PUBLIC COMMENT FORM Badger Pass Ski Lodge Rehabilitation Environmental Assessment

RECEIVED
RBP-S-31
FEB 17 2009
Pg 1 of 1
YOSEMITE NATIONAL PARK

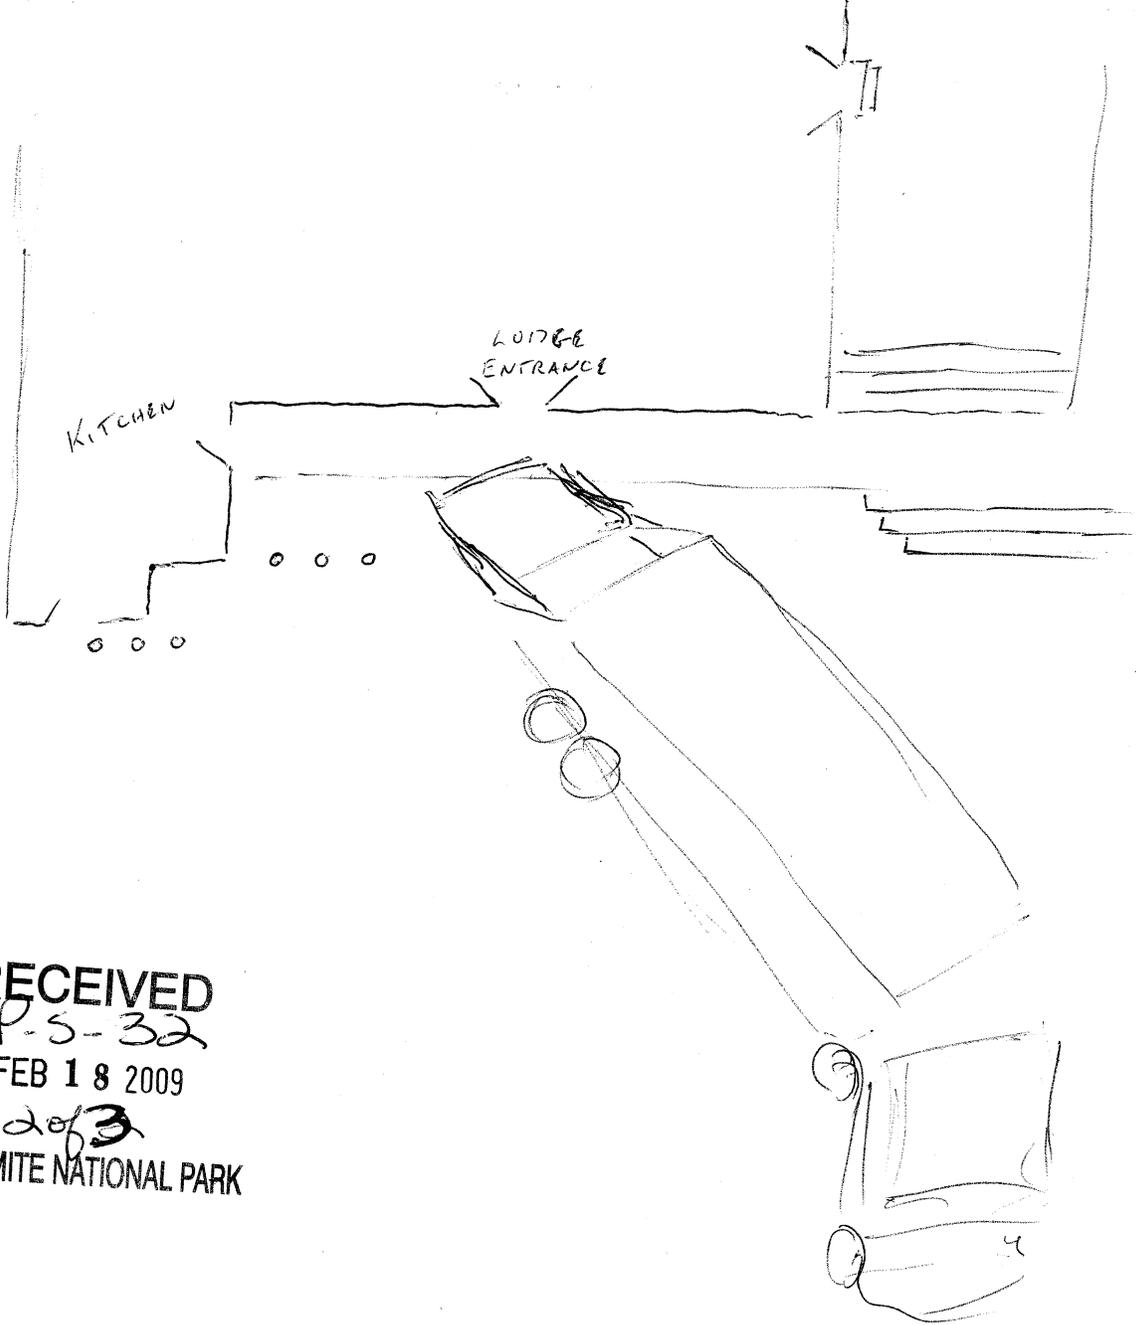
① WE NEED TO HAVE A LOADING DOCK OR A FLAT LEVEL AREA AT THE KITCHEN DOOR SO THE TRUCK CAN BACK IN AND UNLOAD AND NOT BLOCK THE TRAFFIC FLOW IN FRONT OF THE LODGE AND NOT CREATE A SAFETY HAZZARD FOR PEOPLE GOING IN OR OUT THE FRONT DOOR.

② WE NEED BETTER DRAINAGE IN FRONT OF THE BUILDING TO PREVENT THE BUILD-UP OF ICE AND THE PUDDLES AND SLUSH PEOPLE HAVE TO WALK THROUGH GETTING IN & OUT OF THE LODGE AND TO FROM THE BUSES.

CURRENT SITUATION

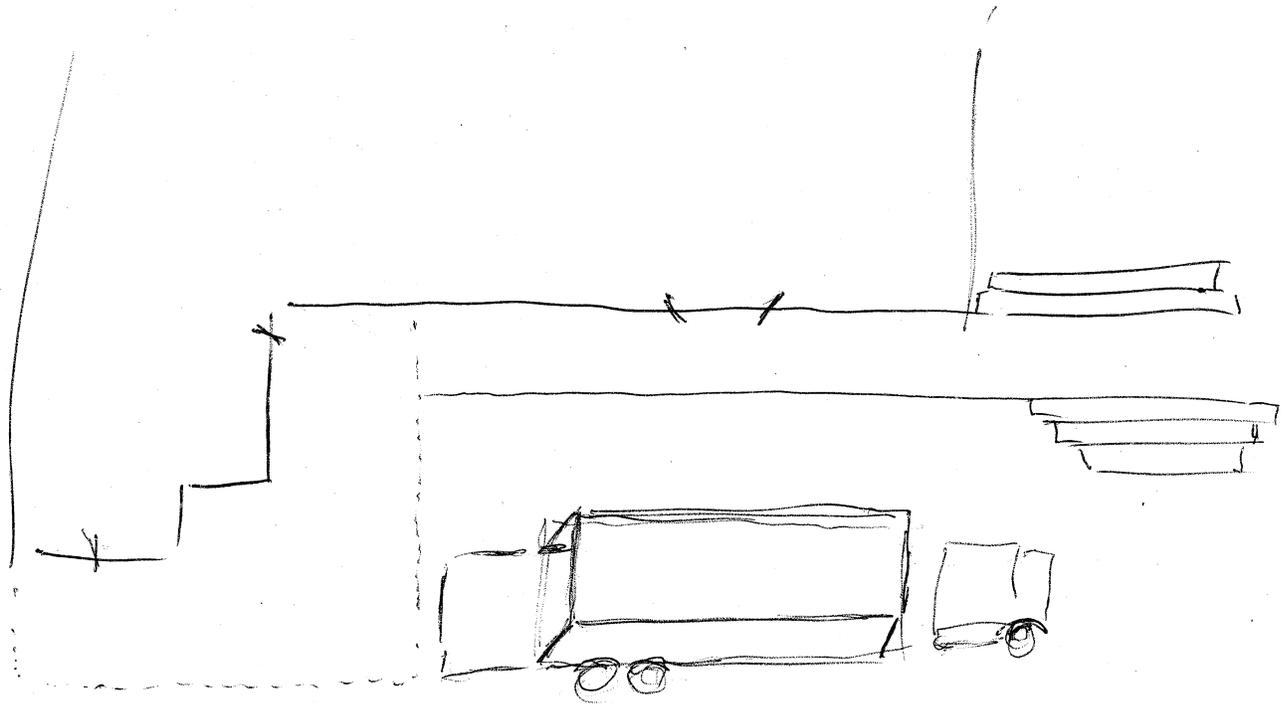
TRUCK PULLS IN, JACK-KNIFES INTO POSITION TO UNLOAD ON FLAT SURFACE WALKWAY AT FRONT DOOR, BLOCKS ENTIRE ROADWAY. CREATES HAZZARD RAISING AND LOWERING LIFT GATE WHERE PEOPLE WALK THRU.

NEW LOADING PAD TO SERVICE BOTH KITCHEN DOORS
TRUCK BACKS STRAIGHT IN ALLOWS TRAFFIC TO PASS
PEOPLE CAN EASILY GET AROUND TRUCK TO FRONT DOOR.
